McGuire
Environmental
Consultants, Inc.

June 12, 1998

Review of Reports Entitled “Phase 1 Treatability Study Draft Report Perchlorate in Groundwater Baldwin Park Operating Unit San Gabriel Basin” and “Phase 2...”

Figure 1. Alternate Arrangement of Unit Processes for Phase 2 Testing

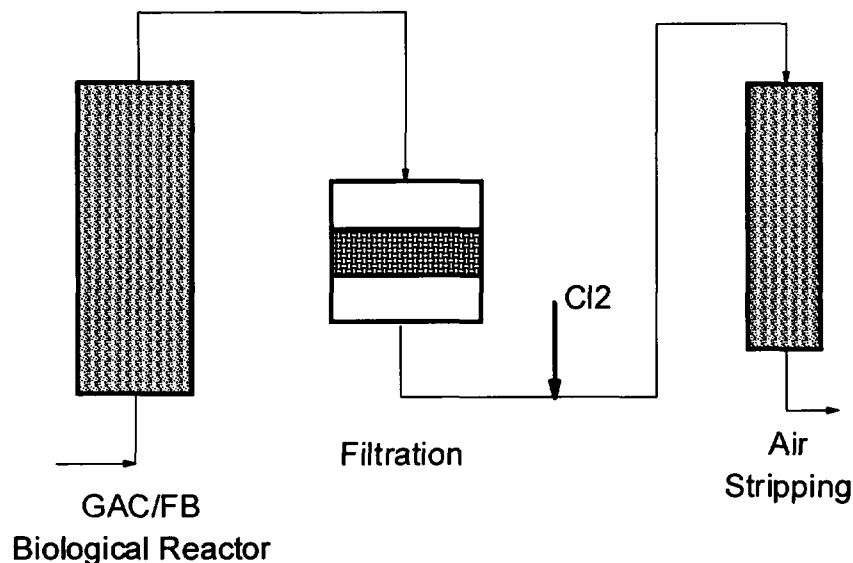
The report assumes that disinfection with chlorine and filtration will fix the biological problem, but they do not discuss any of the treatment process integration or confounding issues. For example, it may be necessary to operate the filter in a “biologically active” mode to remove the organics created by the GAC/FB reactor. If so, chlorination must

follow the filter and not precede it as noted in the experimental plan for Phase 2. Also, adding chlorine at the level to kill the bacteria could cause production of very high levels of DBPs given the production of precursors I referred to above.

Should the DBP tests prove to be satisfactory, I recommend that an alternate arrangement of unit processes be considered. Figure 1 below shows the filtration process following immediately after the biological reactor with chlorination (or disinfection) following after that and preceding the air stripper. This arrangement will allow further removal of organics on a biologically active filter (an oxygen source may have to be added prior to filtration). In addition, the majority of the particles will be removed prior to chlorination which should improve the chlorination process significantly (lower dose, less contact time to get equivalent kill).
